Decision Report to Council for Plan Change 6: Hautapu Industrial Structure Plan

November 2018

WAIPA DISTRICT PLAN: PLAN CHANGE 6 – HAUTAPU INDUSTRIAL STRUCTURE PLAN

Figure 6: Car parking areas at the front of the building is not a desirable outcome.

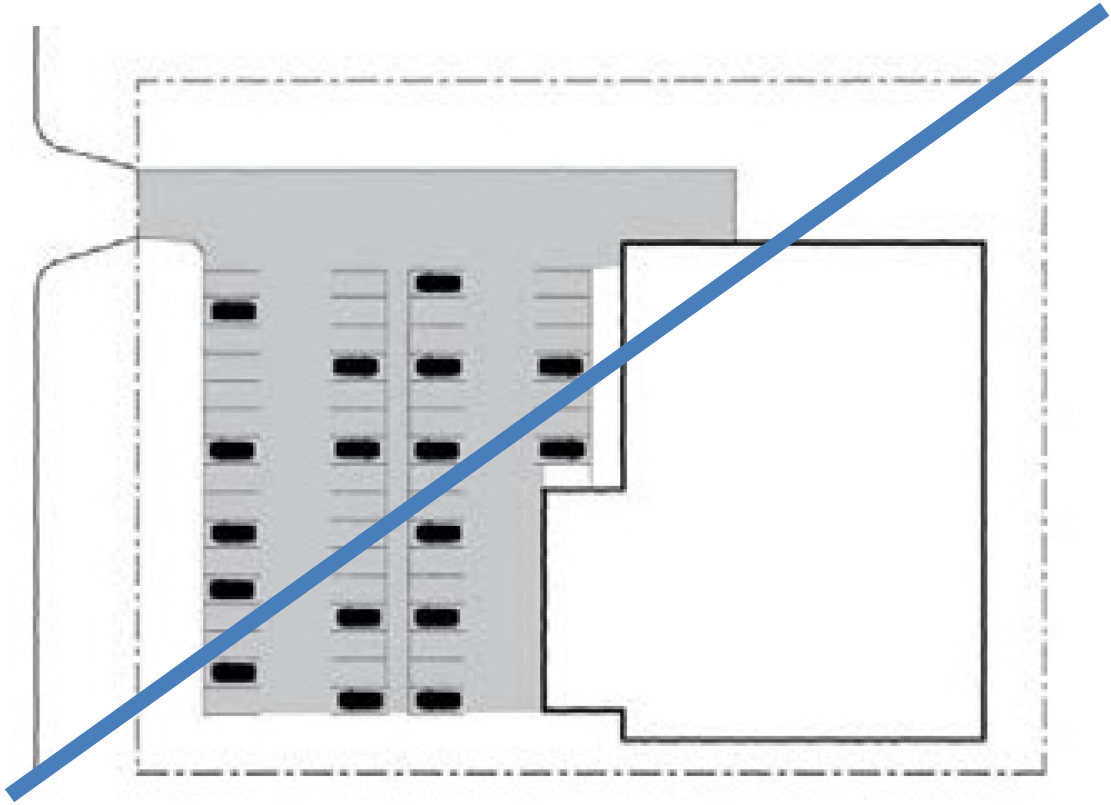
19/2		Provision 2.13 and Figure 6.	Oppose	Delete Design Guideline 2.13 and Figure 6.	Accept With deletion of guideline 2.13
19/5		Provision 2.20	Support in part	Amend Design Guideline 2.20 as follows: Car parking areas should be designed with a regular grid of shade trees, of a suitable species, between parking rows at a ratio of approximately 1 tree per 8 car bays. Refer to Appendix C for a	Accept With amendment of guideline 2.20

- Delete Figure 6

S5.12 Typical Stormwater Sections – Sheet 1 of 3

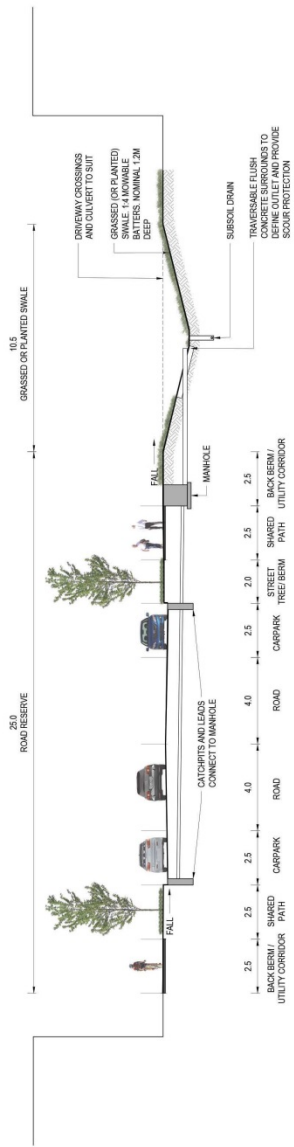
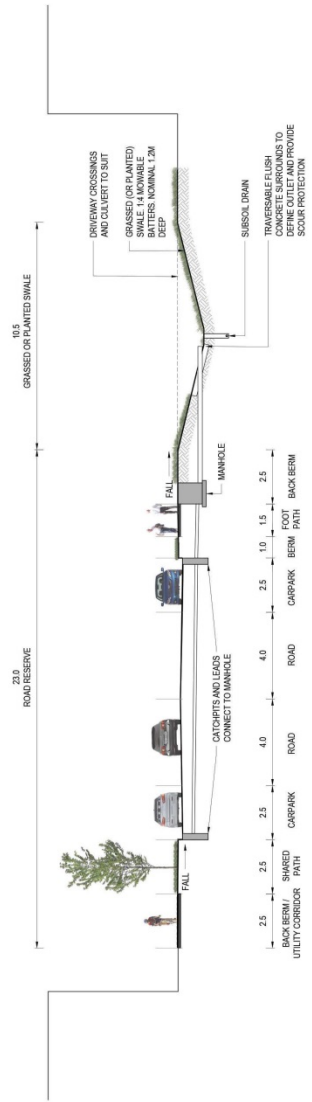
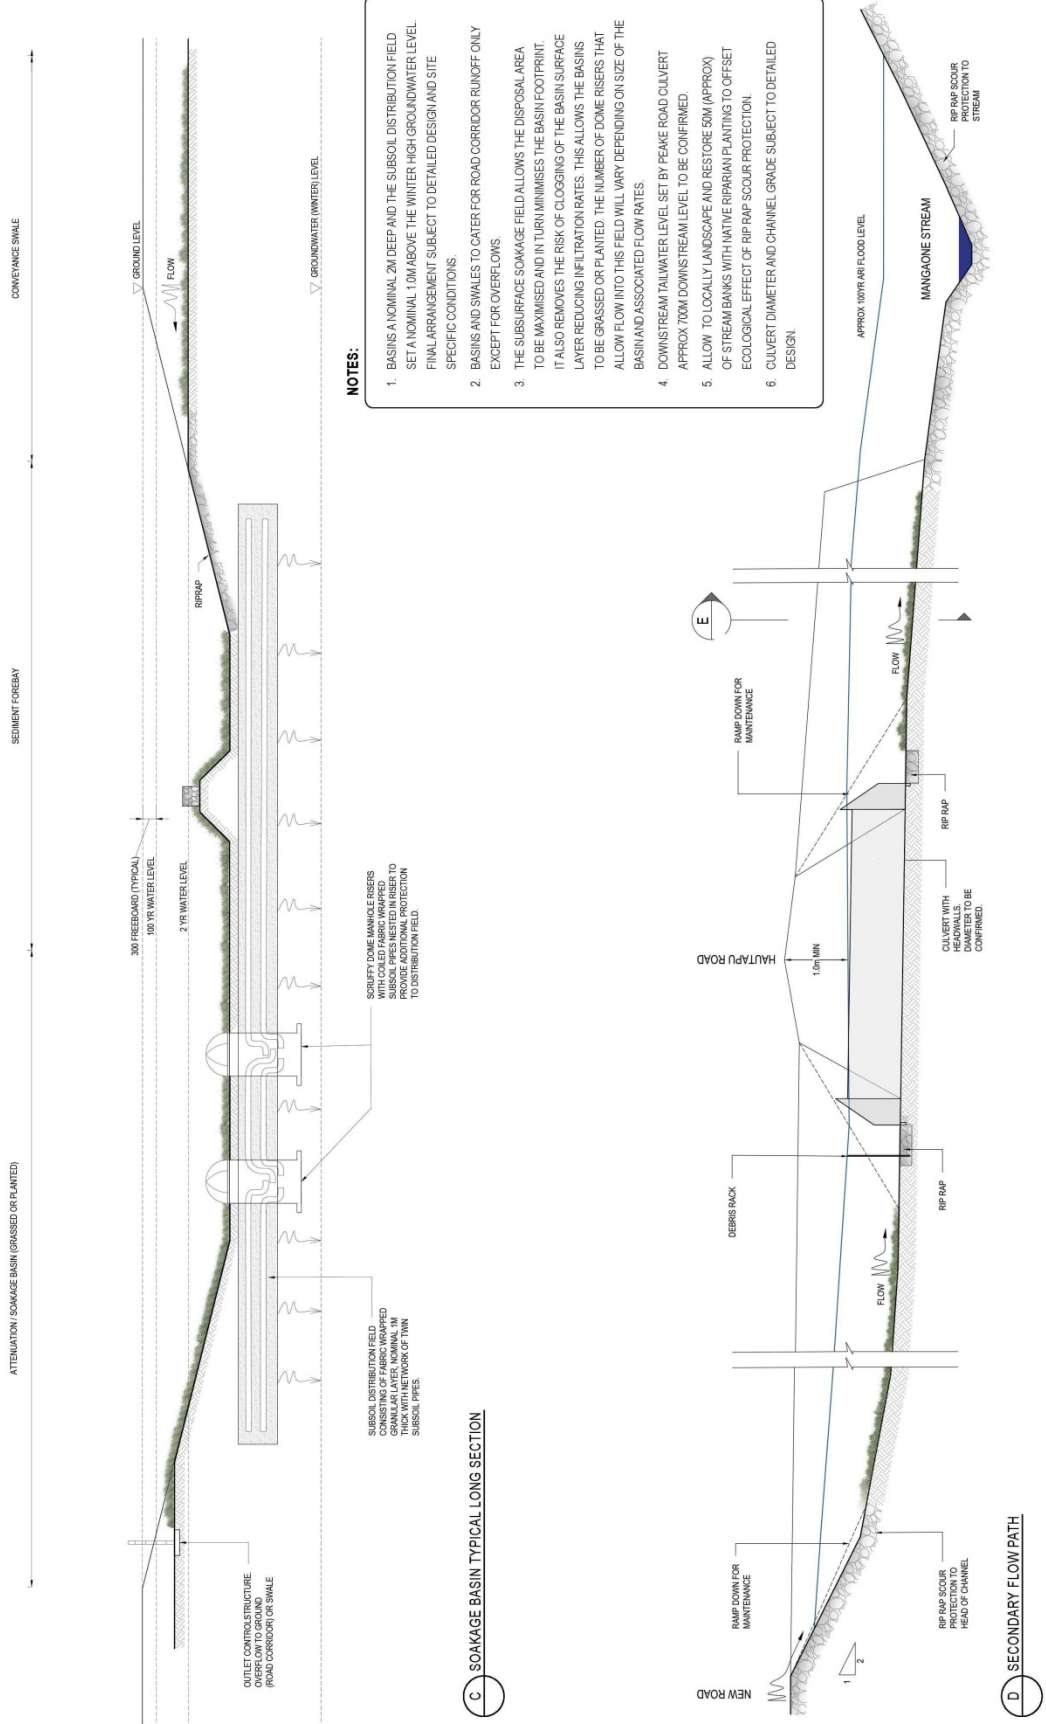
1.11.4 Two submission points 5/6 and 7/5 requested to change the titles of Typical Stormwater Sections – Sheet 1 to 3 to Indicative ~~Typical~~ Stormwater Sections – Sheet 1 to 3. This change would improve consistency of terminology on the diagrams and therefore **these submission points are accepted** and the titles changed as follows:

- *Amend Stormwater Structure Plan Sheets 1-3 to read as heading: ~~Typical~~Indicative Stormwater Sections.*

Appendix B: Perimeter Boundary Treatment

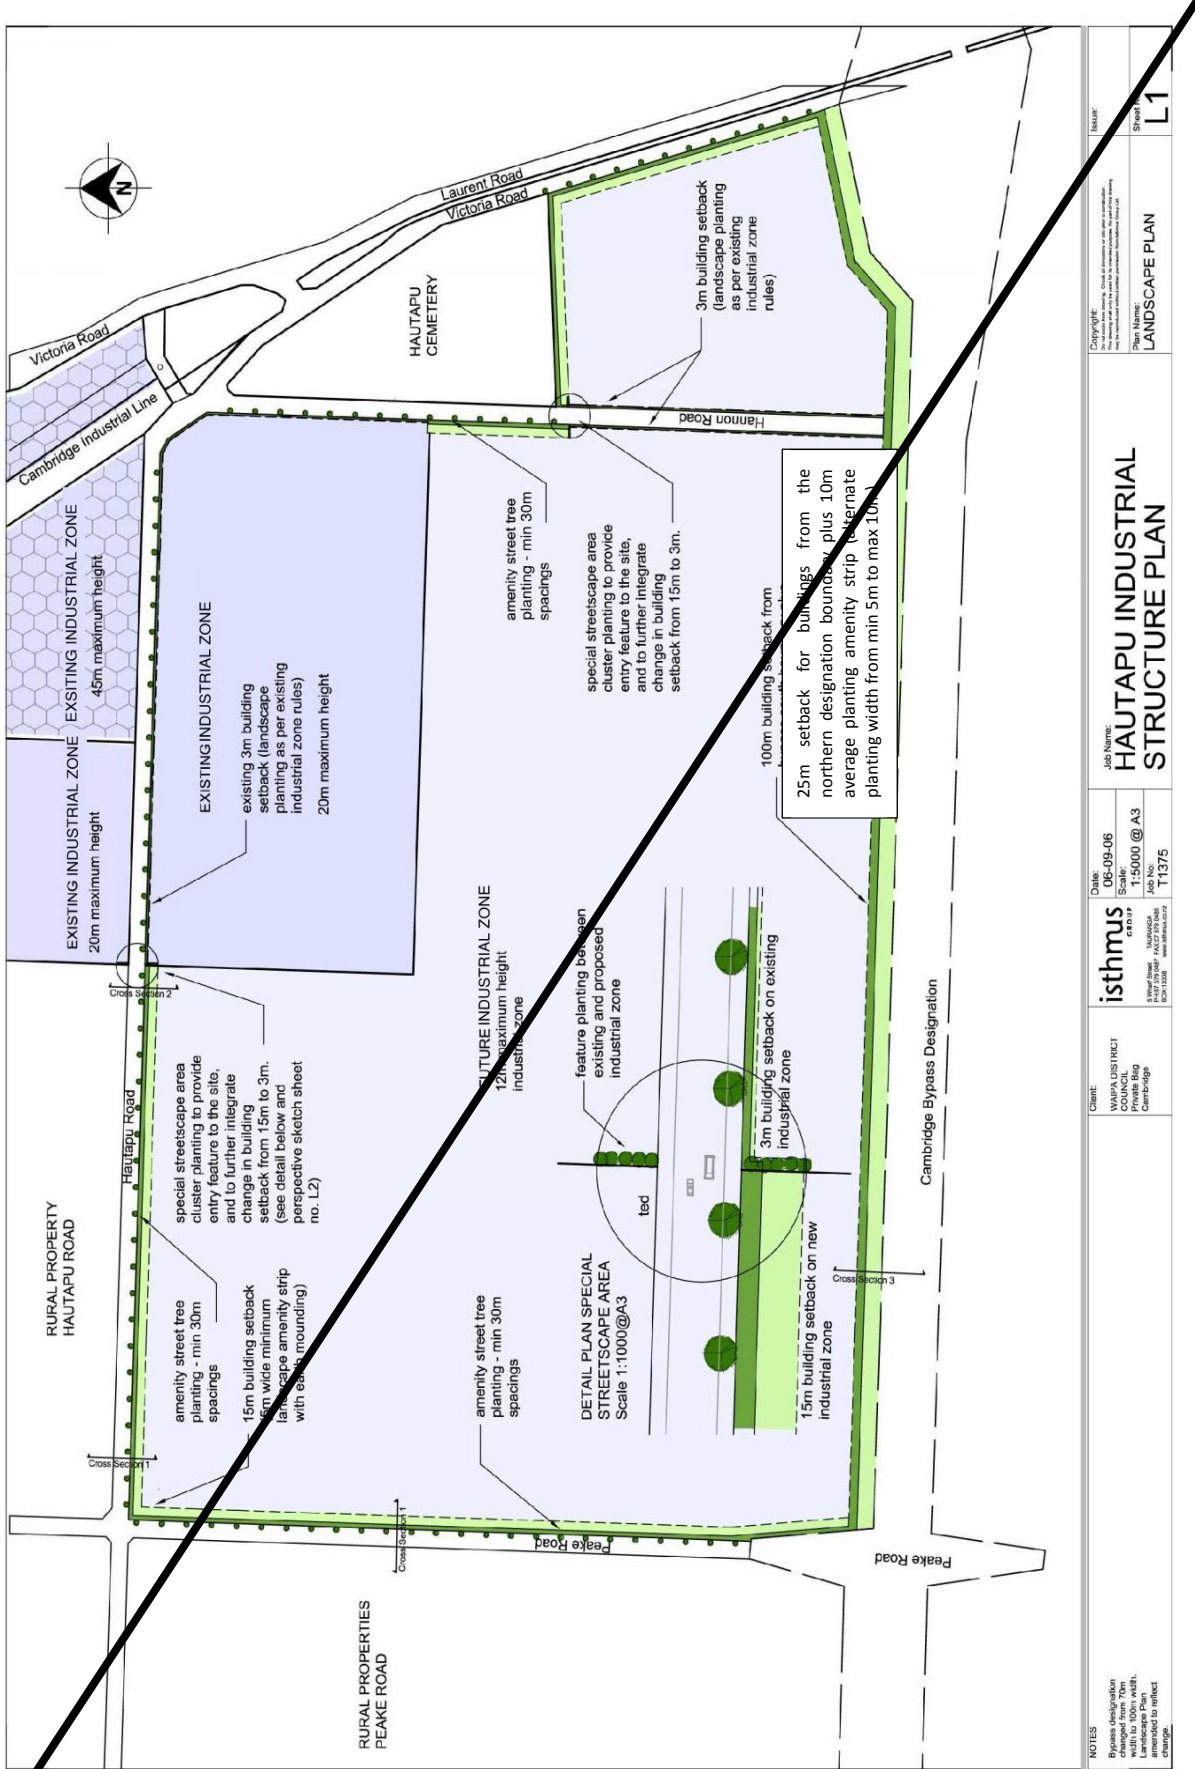
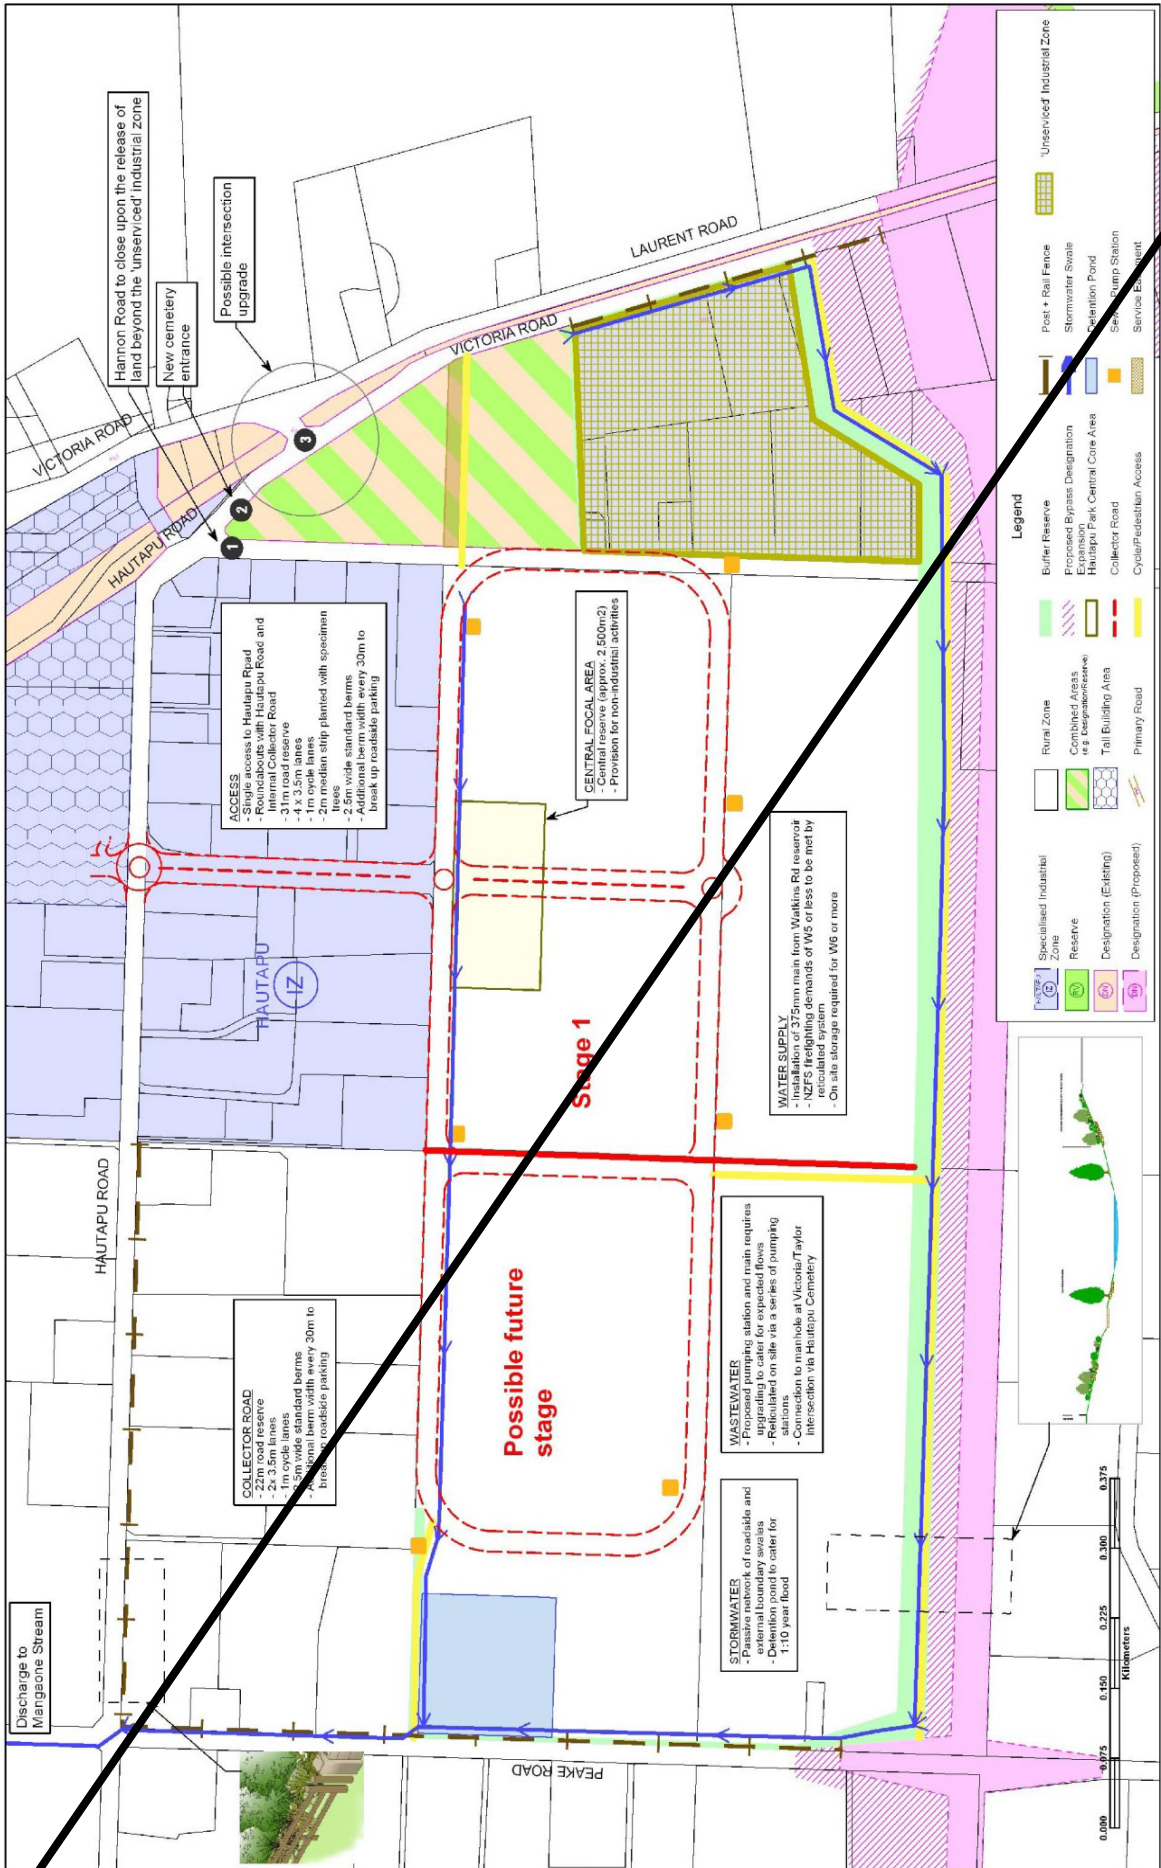
Submission / Point	Submitter	Provision / Reference	Support / In Part / Oppose	Decision Requested	Recommendation
12/5	Hefin Lloyd Davis	Hautapu Structure Plan	Oppose	Include a key on Appendix B: Perimeter Boundary Treatment.	Accept With amendment to diagram
19/24	Waipa District Council	Provision S5.2.7 and related Section 7 - Rule 7.4.2.13	Support in part	Amend numbering of design guidelines, figures in Appendix S5.2.7 as well as clauses in Rule 7.4.2.13.	Accept
